July 6, 2018

Amanda Lessard, Town Planner
Town of Windham
8 School Road
Windham, Maine 04062

Re: Response to Review Comments – Ruby Meadows Subdivision

(207)657-3330
Date
June 2018
Job No.
218035

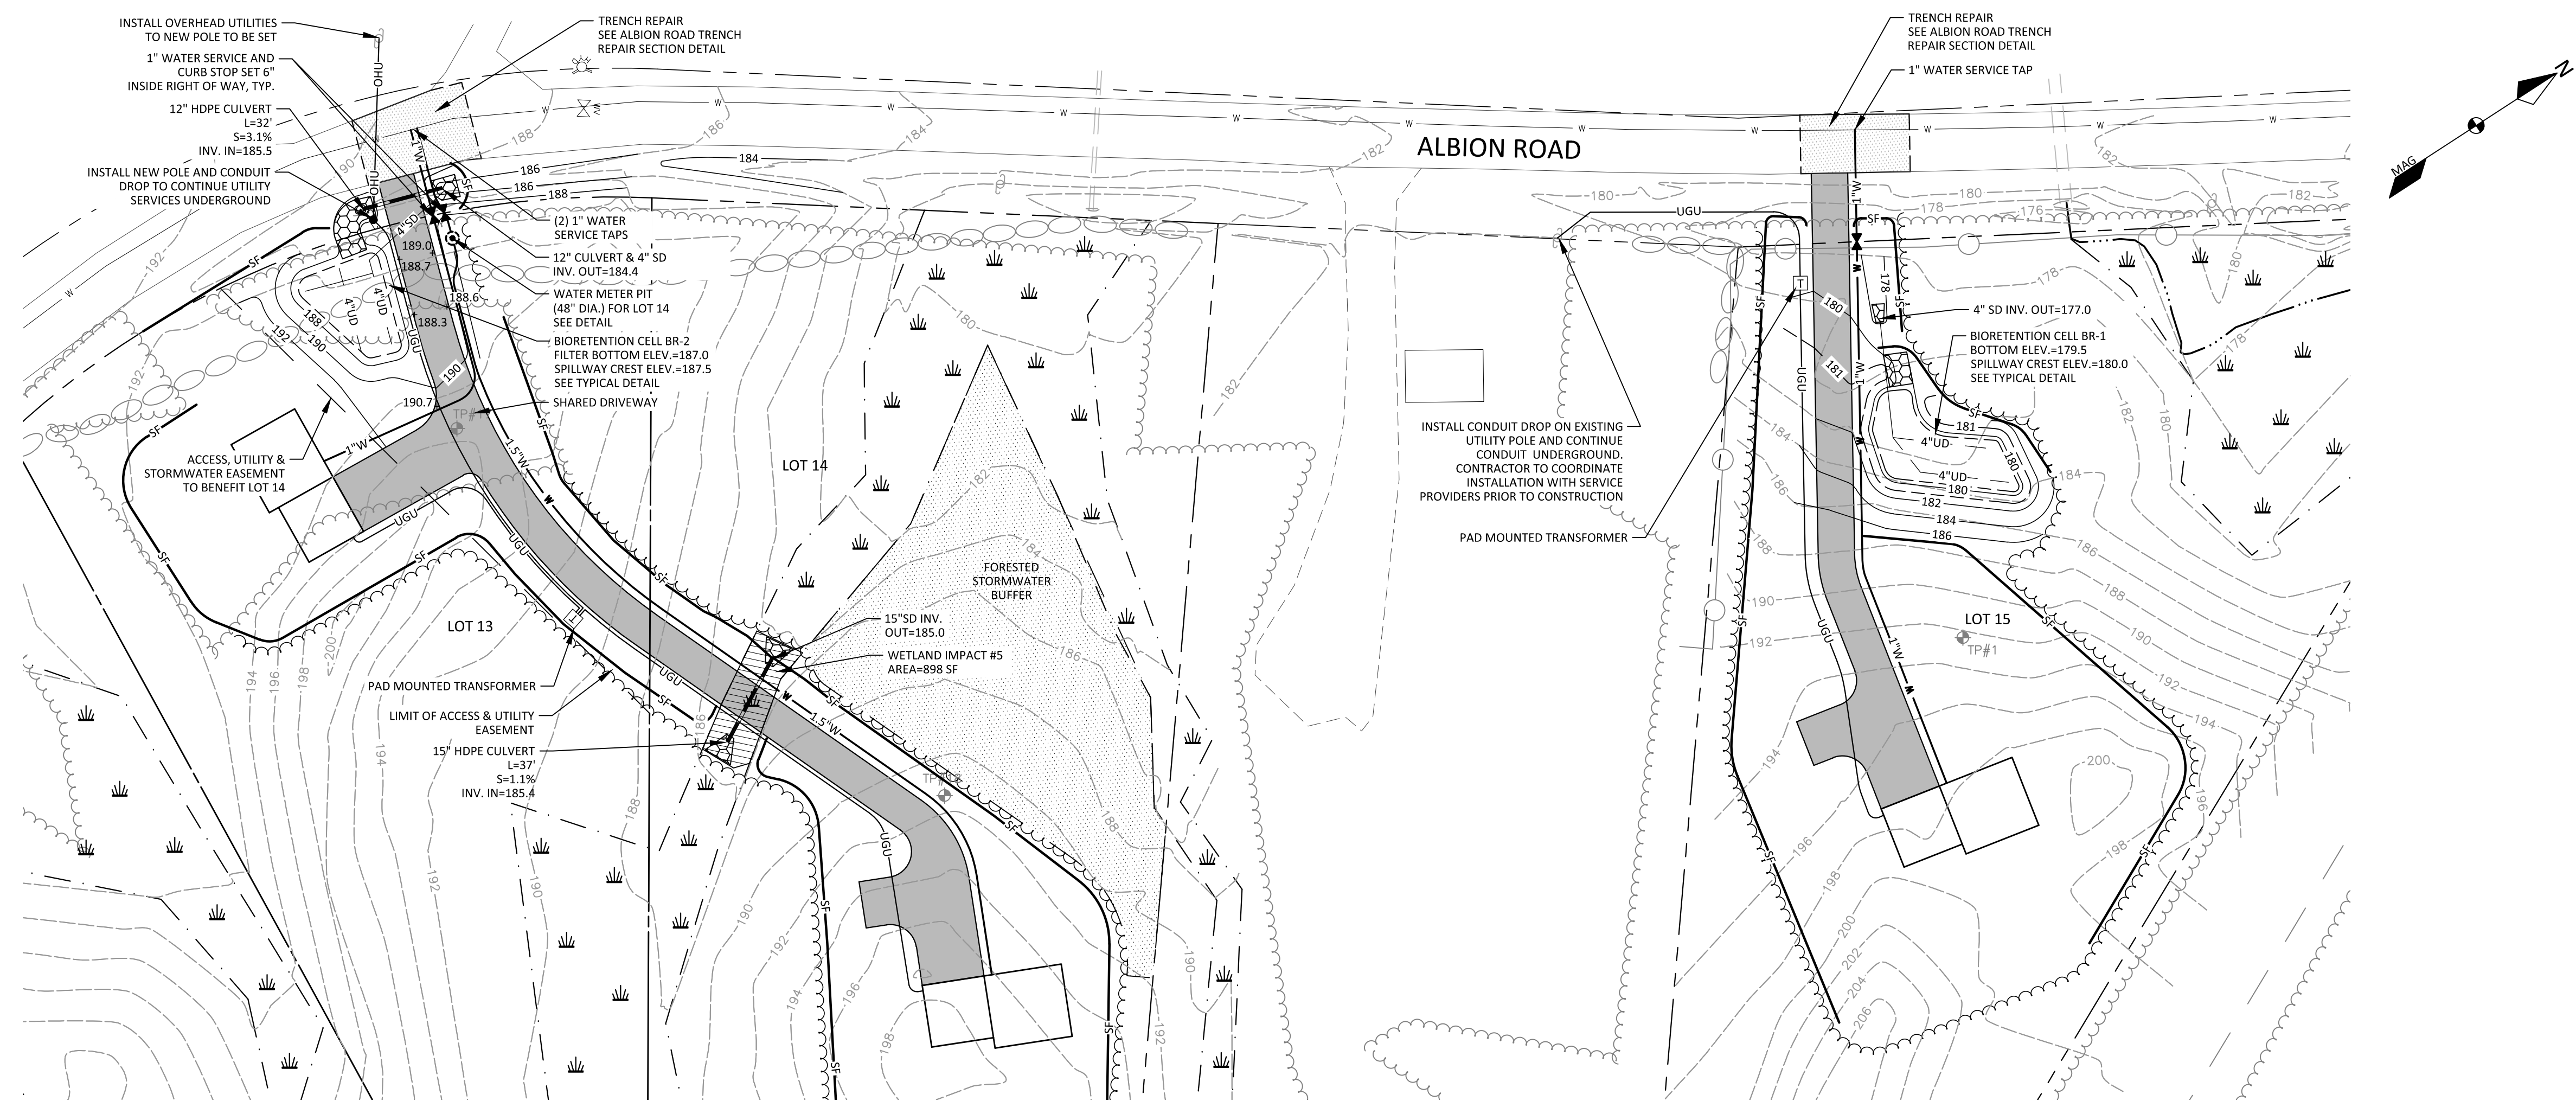
18. A revised Plan and Profile drawing is attached, which labels the sight distance at the proposed roadway intersection.
19. A roadway restoration detail was added to the plans showing the required trench repair and surface restoration for roadway trenching in Albion Road, which is under moratorium.
20. A revised Stormwater Management Report is attached, which correctly labels the pre-development flow rate at Study Point 1 as 7.18 CFS.
21. We propose that ground topography of the stormwater filter basins and rain gardens be surveyed as a condition of preliminary approval and prior to final approval.
22. A revised Lot Development Plan is attached, which shows proposed grading for the bioretention cells on lots 1, 2, 13, 14 and 15.
23. A summary table showing the proposed impervious and developed area on each lot was added to the Subdivision Plan.
